CR238 – Oil Cooler Hose Spacer Installation

Hypermotard 939 STD/SP MY16-18 (all versions)
Hyperstrada 939 MY16-17 (all versions)
Safety Recall Campaign SRV-RCL-22-002

Date: September 27, 2022
To: Dealer Principal, General Manager, Service Manager, North American Dealer Network
From: Richard Kenton, Technical Director
Dan Schwartz, Service Area Manager

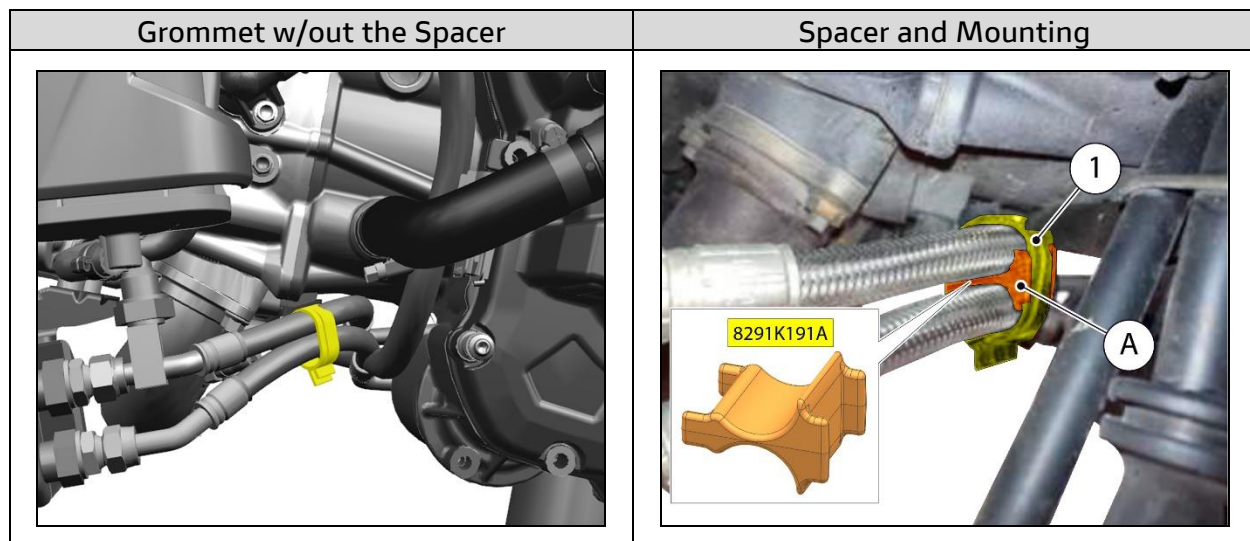
This bulletin has been produced due to a potential problem associated with the rubbing of the oil cooler delivery and return hoses, which could lead to damage and oil leakage from the hoses. A new component, **spacer (A) (Part no. 8291K191A)**, has been made to be placed between the hoses and inside the **hose grommet (1)**, to prevent the contact described above.

The **spacer (A) (Part no. 8291K191A)** must be installed only on motorcycles equipped with **hose grommet (1)**.

Service Solution

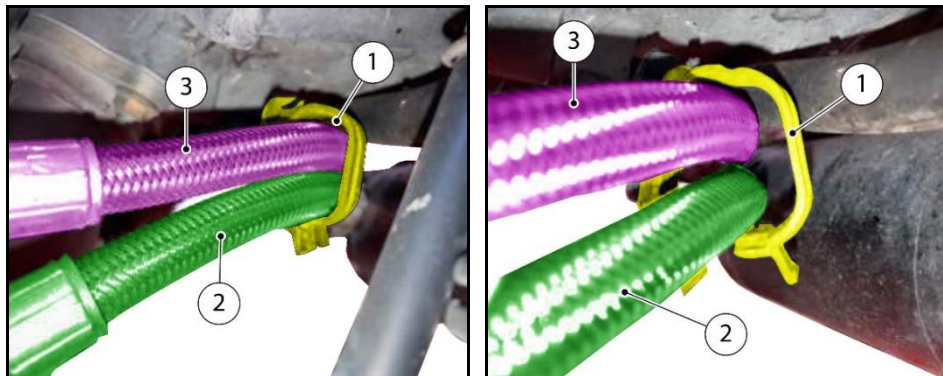
1. Position the motorcycle on a rear paddock stand
2. FOR HYPERSTRADA ONLY: Remove the sump guard
3. Release hose grommet (1) and move oil return lower hose (2) away from oil delivery upper hose (3)

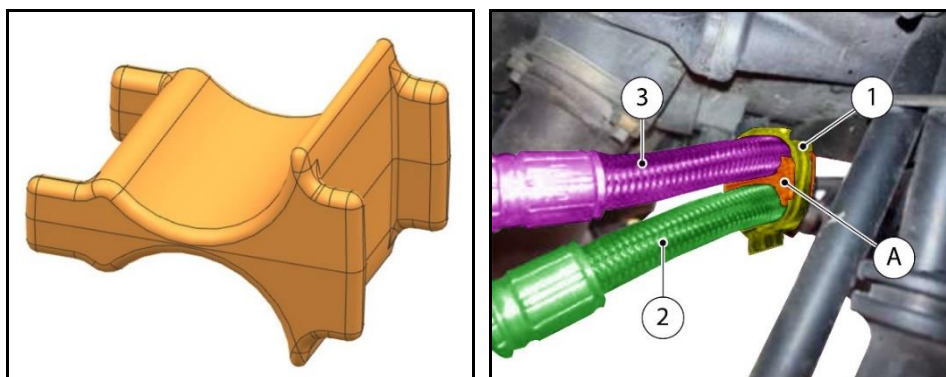
Check the condition of the oil cooler delivery and return hoses. If they are damaged, please submit a Youtech with a request for replacement hoses. Include photos showing the damage on the hoses.

4. Take spacer (A) Part no. 8291K191A and insert it inside hose grommet (1); then re-hook hose grommet (1) to the closed position

To correctly hook hose grommet (1), exert a slight pressure on its closure.
